# **Safety Evaluation Report**

related to the operation of  
Watts Bar Nuclear Plant,  
Units 1 and 2

Docket Nos. 50-390 and 50-391

NUREG-0847  
Supplement No. 15

Figure 6.1 Divider Barrier Seal

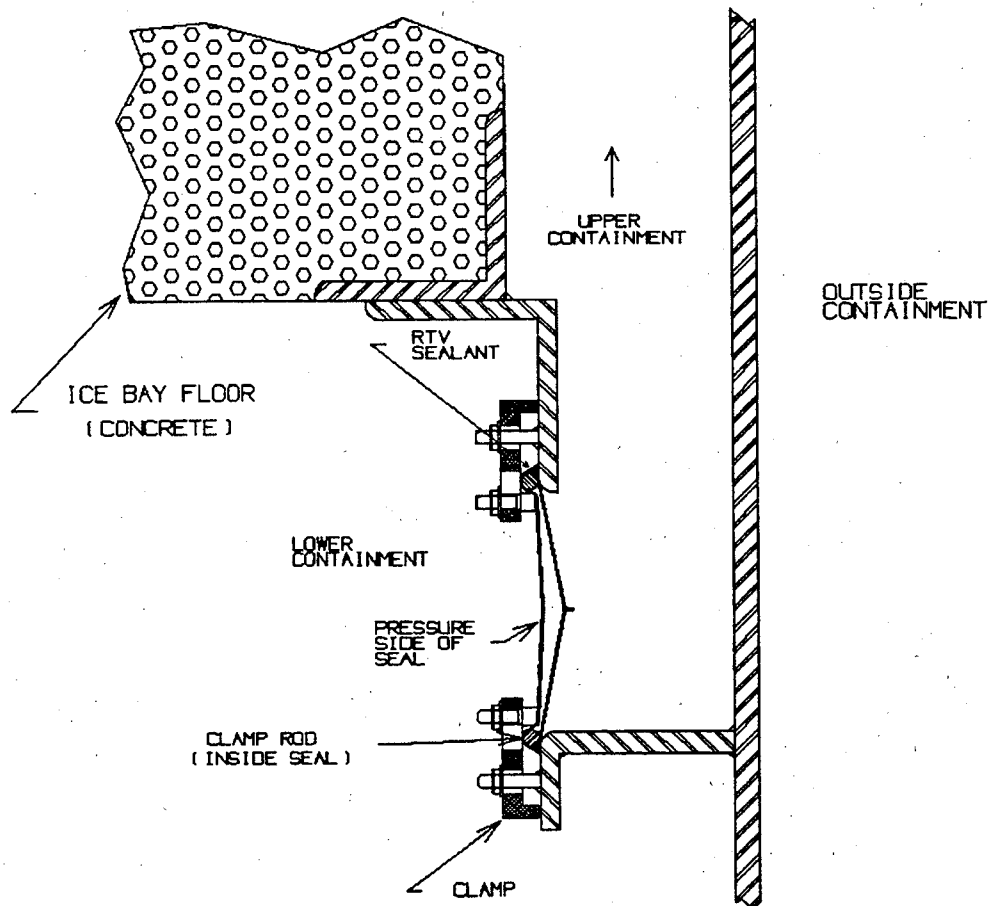
The seal was constructed from flat strips of material consisting of two plies of dacron fabric impregnated with a terpolymer of ethylene propylene diene (Class M of ASTM D1418). The flat strips were folded longitudinally and the edges butted and sewn ("pigtailed") to create individual sections in the form of a "tube." During installation, the individual sections were field-spliced in place with vulcanized joints to form one long continuous seal. In order to make the field splices, the pigtailling was removed in area of the overlap of the sections being joined. During installation, metal bars of 3/8-inch diameter were inserted into the seal for use in attachment to the containment structures with bolted clamps. Slack was provided to allow for seismic movement between the containment shell and interior structures forming part of the divider barrier. Room-temperature-vulcanized (RTV) sealant was applied to the exposed area where the seal contacts the structure. The seal vendor is the Presray Corp. Presray is a major supplier of seals used in the industry for airlock doors, refueling cavity seals, and such. Figure 6.1 depicts a typical cross-section of the seal in an unspliced location. The seal used at Watts Bar is the same as the seal used at Sequoyah. The Sequoyah and Watts Bar seals are of a different design from those of other ice condenser facilities; other facilities use a thick, solid seal material.

The divider barrier forms part of the boundary between the upper and lower compartments of the primary containment. During the blowdown phase of a LOCA, a significant pressure difference may exist between these upper and lower compartments. If the divider barrier leaks, the resultant ice condenser bypass leakage could cause the analyzed peak accident containment pressure to be exceeded. During the post-blowdown phase of an accident, the seal is subjected only to the relatively low differential pressure resulting from operation of the upper containment air return fans; however, its integrity

continues to be important for proper long-term ice condenser operation. The applicant reviewed the potential effects of additional LOCA steam bypass due to divider barrier seal leakage, and found that the effects of leakage due to small cracks would be insignificant. The staff did not review the applicant's calculation; however, the staff noted that other analyses have shown that ice condenser containments can tolerate a relatively high amount of steam bypass (e.g., "The Effect of Steam Bypass on Ice Condenser Containment Pressurization," G. Pertmer et al., MDNE-82-111, Department of Chemical and Nuclear Engineering, University of Maryland, July 1982).

The cold-splice adhesive used in the installation of the material that replaces the removed specimens has been found to provide sufficient strength for LOCA integrity in the tested (unaged) conditions, but to be vulnerable to heat aging. As indicated above, its condition must, therefore, be monitored through additional unique periodic surveillance testing. Peel tests would be performed on test specimens at 18-month or 36-month intervals, the interval for each joint location being dependent on the initial peel test result for that location. The peel test procedure and recommended test intervals are described in Presray Report No. PR16550, "Procedure for Cold Bonding Divider Barrier Seal Splice Joints." The staff reviewed the report while on site on February 23, 1995. The test specimens are not part of the actual divider barrier seal. They are specimens of material removed during the repair and are located near the seal at each splice joint.

The staff reviewed the information submitted by the applicant and concluded that a revised divider barrier seal surveillance program is appropriate for Watts Bar Unit 1. The tensile testing may be deleted based on the additional testing that demonstrates that the seal material, including the original vulcanized joints, is qualified for a 40-year life and DBA-LOCA. Additional peel tests on test coupons will be performed periodically to monitor the condition of the adhesive used in the cold-bond/bolted splices. The test frequency for the peel tests will be as recommended by the vendor.
